Attachment 1 - PLN20/0504 - 42 O'Grady Street Clifton Hill - Decision Plans

**Attachment 2 - PLN20/0504 - 42 O'Grady Street Clifton Hill - Engineering Services referral comments**

**To:** Jessica Sutherland  
**From:** Artemis Bacani  
**Date:** 6 October 2021  
**Subject:** Application No: PLN21/0504  
 Description: Medical Centre  
 Site Address: 42 O'Grady Street, Clifton Hill

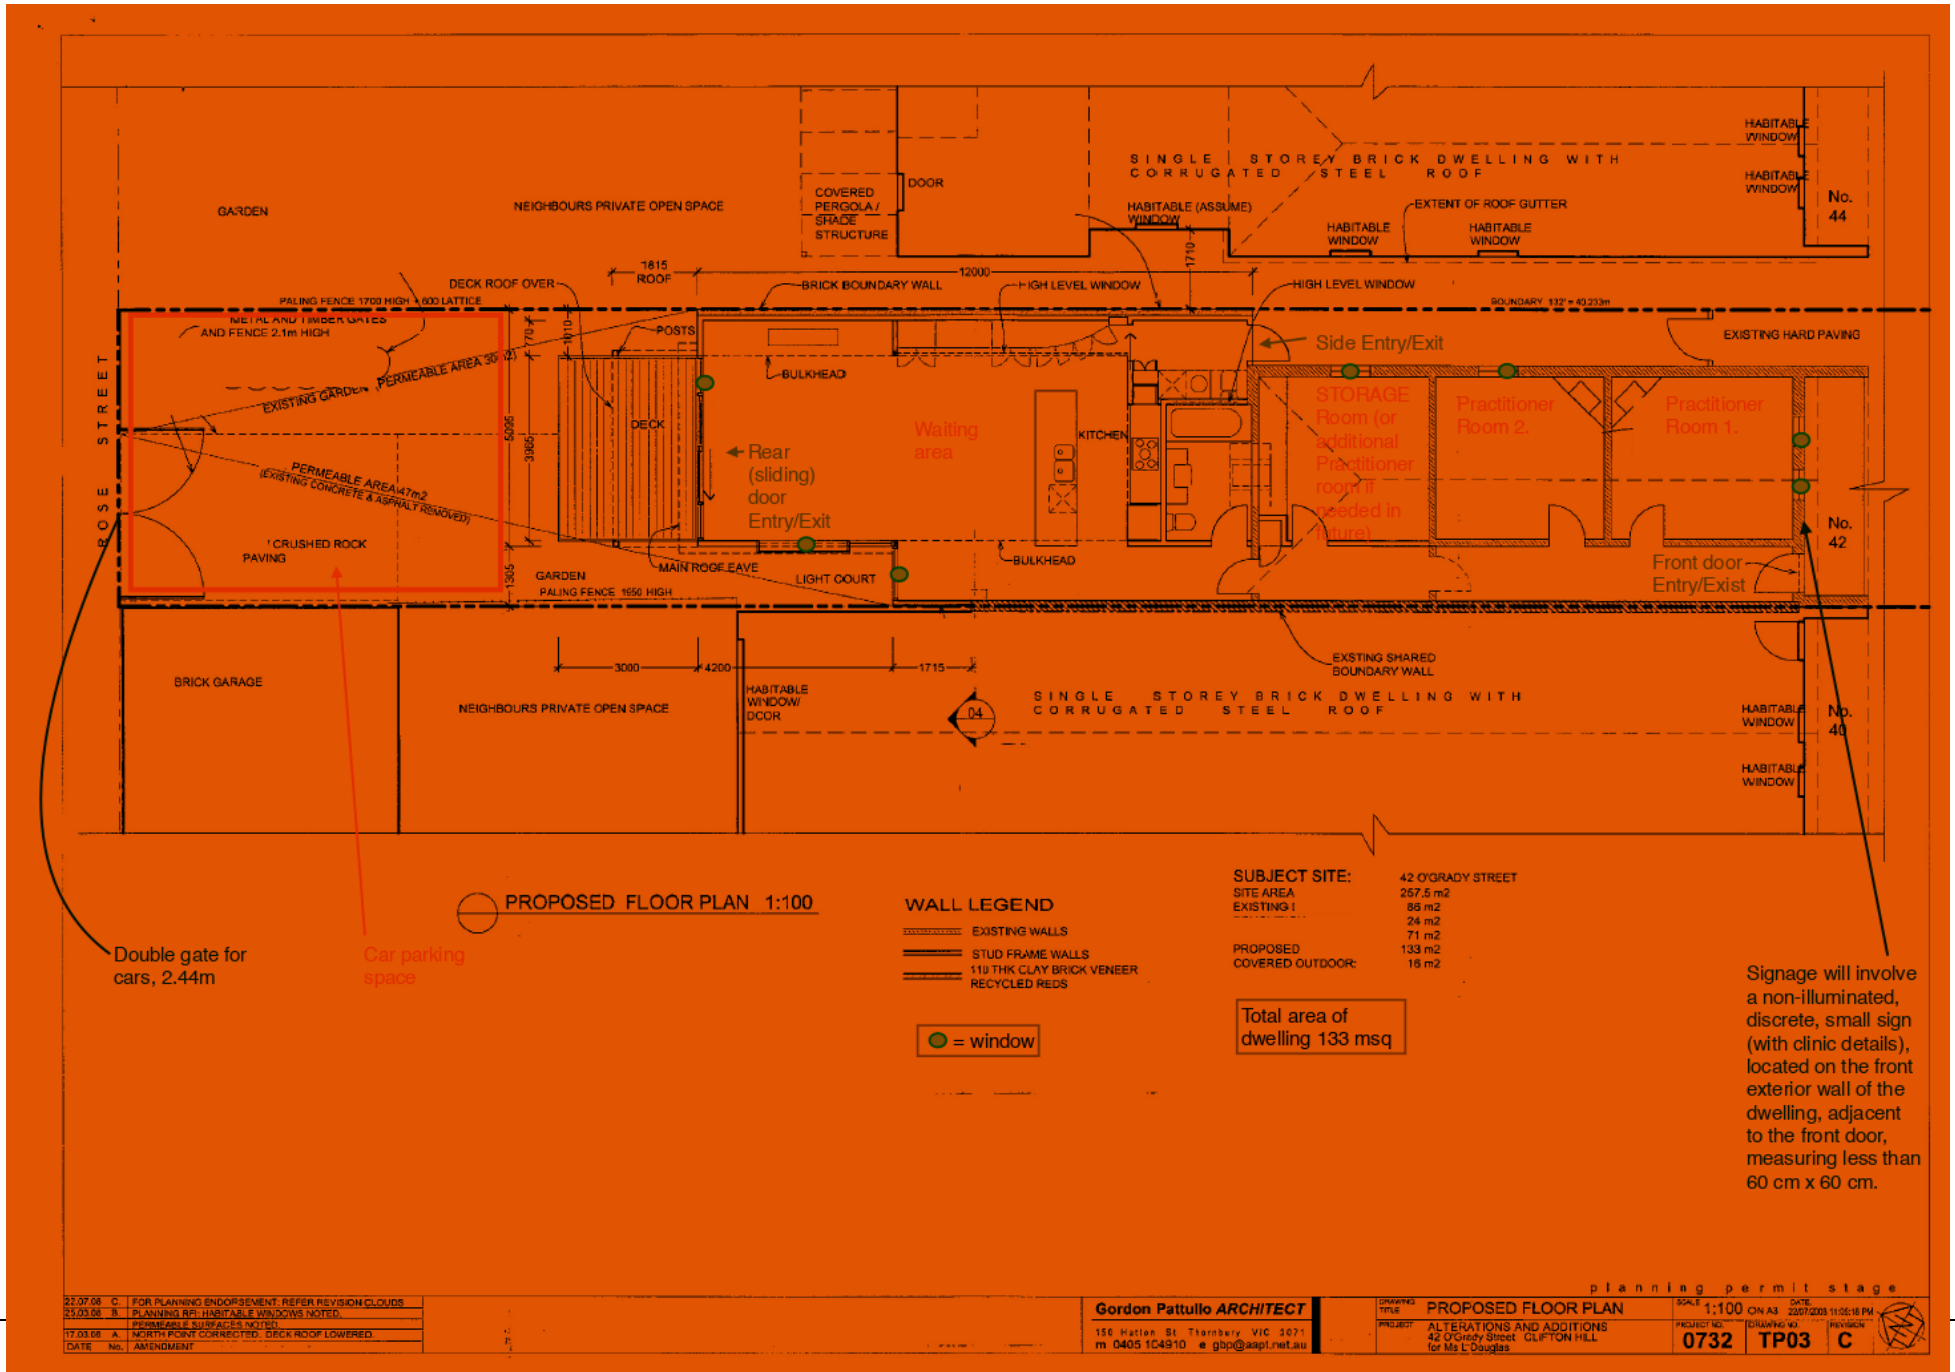
From a traffic engineering perspective, the reduction of parking associated with the medical centre is considered appropriate in the context of the development and the surrounding area. Patients would be fully aware of the parking demand in Clifton Hill and instead commute to the site by utilising sustainable transportation modes.

The Engineering Referral team has no objection to the reduction in the car parking requirement for this site.
